Technical product information

Topic	Steering malfunction message displayed on dash, DTC 'C10AC07-Steering mechanical malfunction' stored
Market area	Bentley: worldwide (2WBE),Hongkong-Macau (5HK)
Brand	Bentley
Transaction No.	2051802/1
Level	EH
Status	Approval
Release date

Steering malfunction message displayed on dash, DTC 'C10AC07-Steering mechanical malfunction' stored

Figure 1

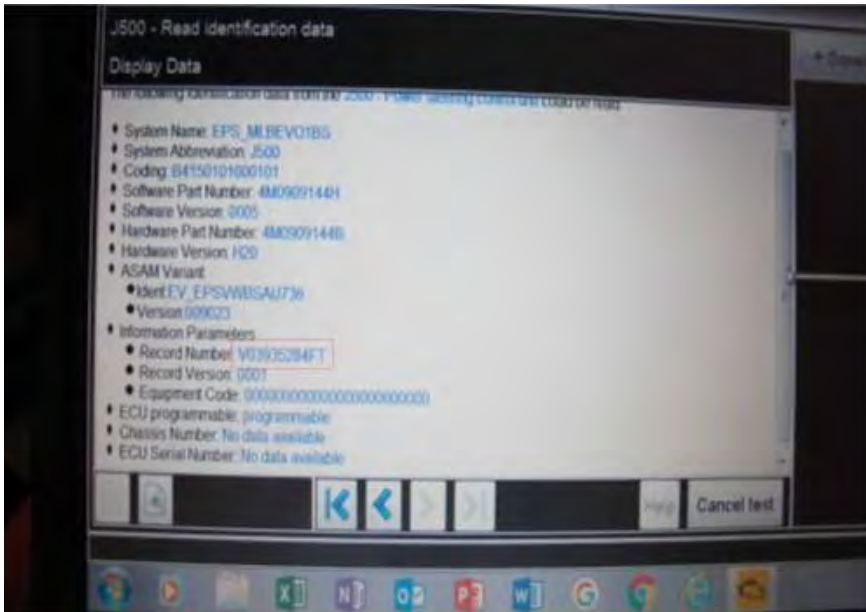
Under the title **Information Parameters**, the **Record Number** should end in suffix **FT**, see *Figure 1*. This confirms the procedure has been successful.
